APPLICATION NUMBER: 25/0220

PROPOSAL: 26 AFFORDABLE DWELLINGS, NEW ACCESS WORKS, LANDSCAPE PLANTING, A NEW PUMPING STATION AND ASSOCIATED WORKS

SITE: Land at Traston Lane Newport

THE APPLICATION HAS NUMEROUS INCONSISTENCIES AND GAPS

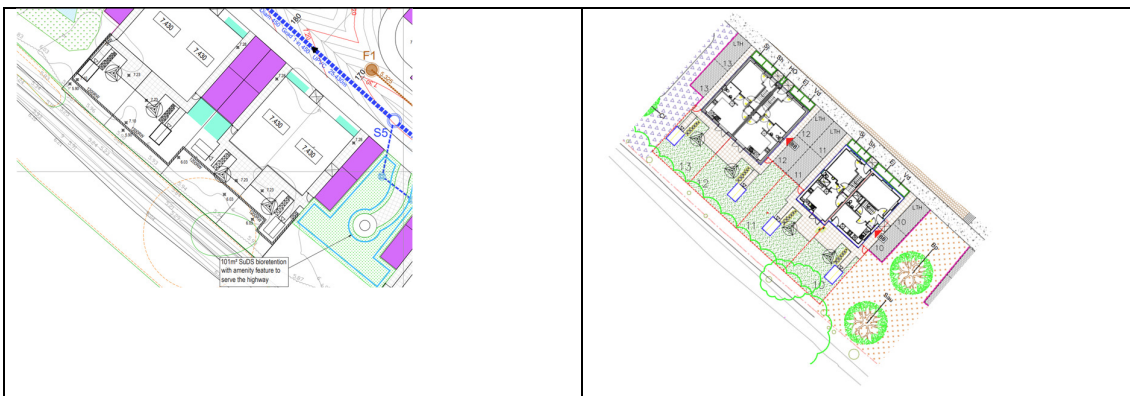
The AIA states 'Of the 62no individual trees and tree groups recorded within and adjacent to the site over 60% of these trees are in a dead, dying or dangerous condition, unsuitable for safe retention in relation to proposed residential development' and lists the following for removal on arboricultural grounds.

- *Arboricultural Reasons Trees G5, T6, T7, T9, T12, T13, G14, T15, T16, T17, T19, T20, T21, T22, G23, T25, T26, G28, T29, T31, T32, T33, G34, T35, T37, T38, T39, T43, G44, T48, T49, T50, G51, T52, T53, T54, T55 and G60 are recommended for removal in the Tree Survey due to poor quality (U category). These are mainly Crack Willow trees that are in serious decline with many stems having collapsed and further structural failure imminent. These trees are not in a suitably safe condition to be retained in close proximity to residential dwellings.*

These proposed losses are not included within the GIS losses – this should be included as their removal is required because of the residential development proposals and suitable compensation should be provided.
